Re: Response dated October 24, 2016 to the Request for Additional Information No.1 (RAI#1) dated September 16, 2016 pertinent to a Waste Tire Processing Facility Permit Modification Application for the American Tire Recycling Group, LLC facility located at, near, or in the vicinity of 3551 NW 116th Street, Miami, Miami-Dade County, Florida; FDEP Project No. 0303329-003-WT / WACS No. 99254 / DERM File No. SW-1731.

**WASTE TIRE PROCESSING FACILITY PERMIT APPLICATION
REQUEST FOR ADDITIONAL INFORMATION No.1 (RAI #1)**

American Tire Recycling Group, LLC

FIGURE 2

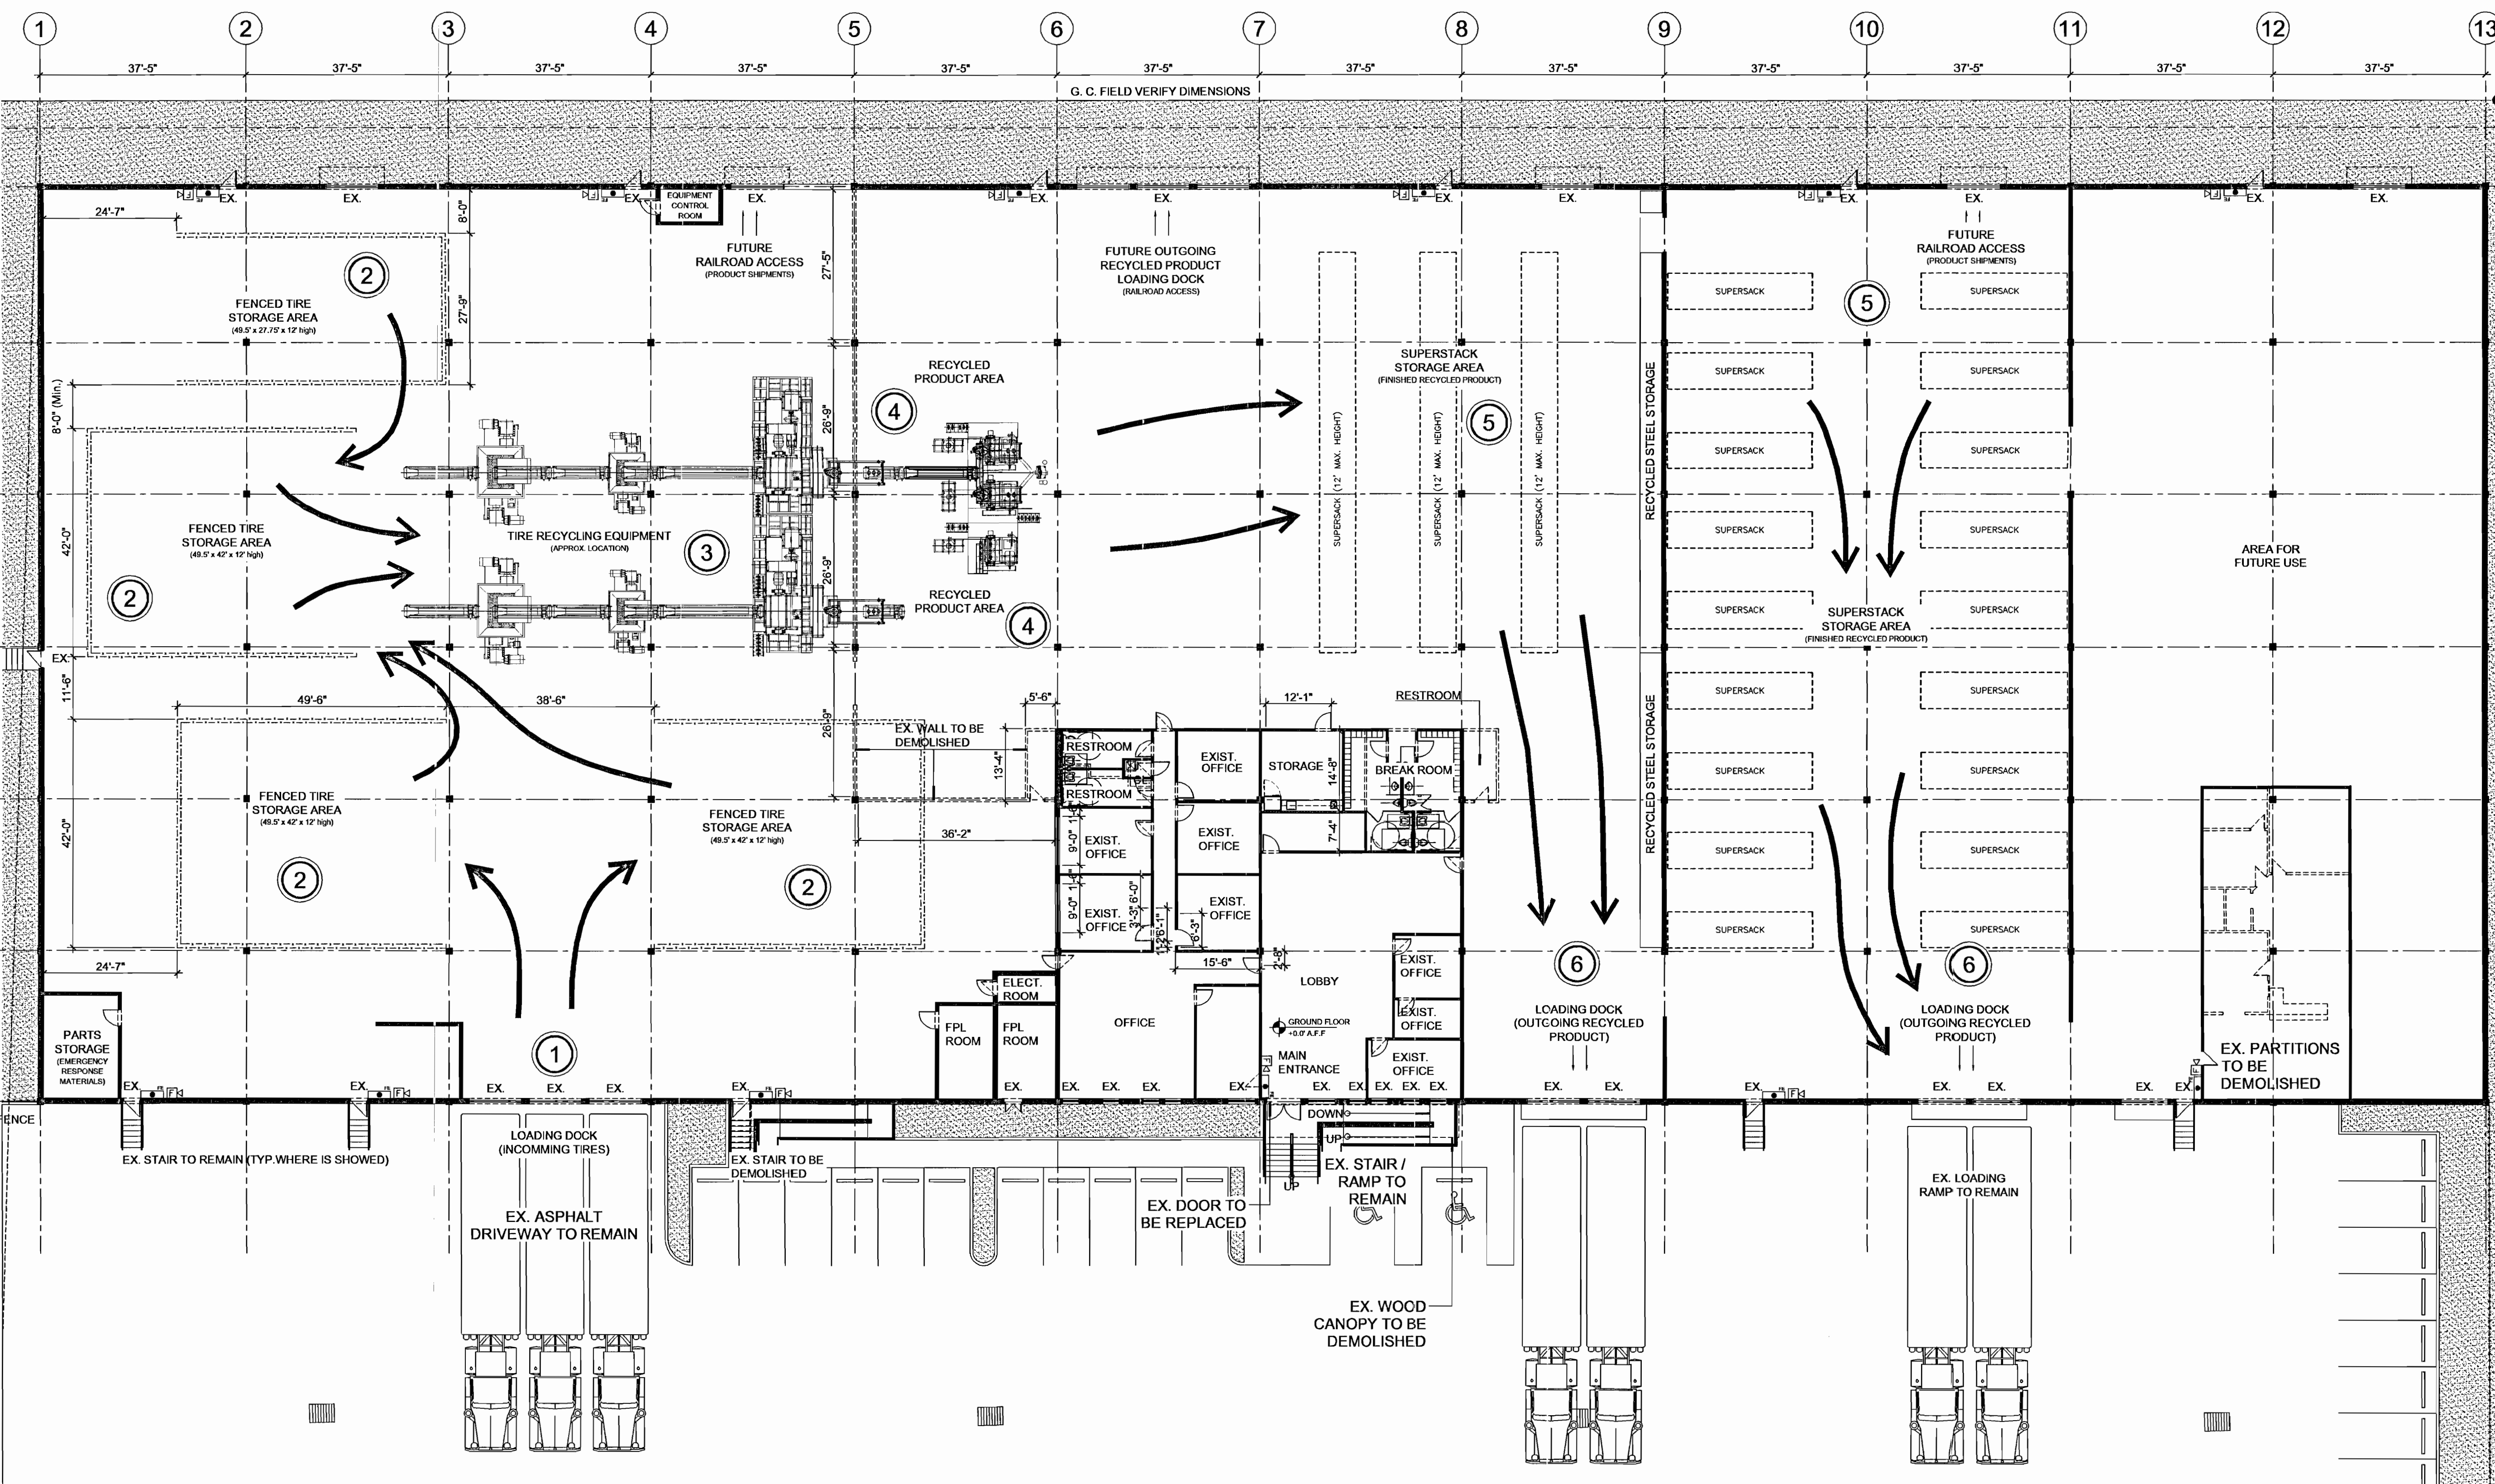
- (b) Pursuant to item (a) above, indicate the maximum volumetric capacity of each area designated for the storage/staging of whole and processed waste tires. Refer to the attached site plan provided with the original permit application that outlines the extents and locations of all such areas of the facility. In the event that the configuration or uses of the areas have changed, an updated site plan shall be provided along with the volumetric capacities. The use of outdoor storage areas (in trailers, storage containers, etc) shall not be assumed/included in the calculations.

- (c) Pursuant to item (b) above, provide calculations demonstrating the maximum quantity of waste tires (whole and processed) that each of the facility's storage/staging areas can accommodate. This demonstration shall be compliant with the storage requirements of Rule 62-711.540, F.A.C. and also consider material circulation and accessibility needs at the site. The response shall also take into account the passenger and truck tire tonnage conversion criteria included in the definition of the term "Quantity of Tires" captured in Rule 62-701.200, F.A.C. If both passenger and truck tires are accepted at the facility, quantity assumptions applicable to each type based on historical data and/or operational experience shall be included. Conversions of whole waste tire quantities to tons of material shall be shown for consistency since both whole and processed waste tires are present at the site.
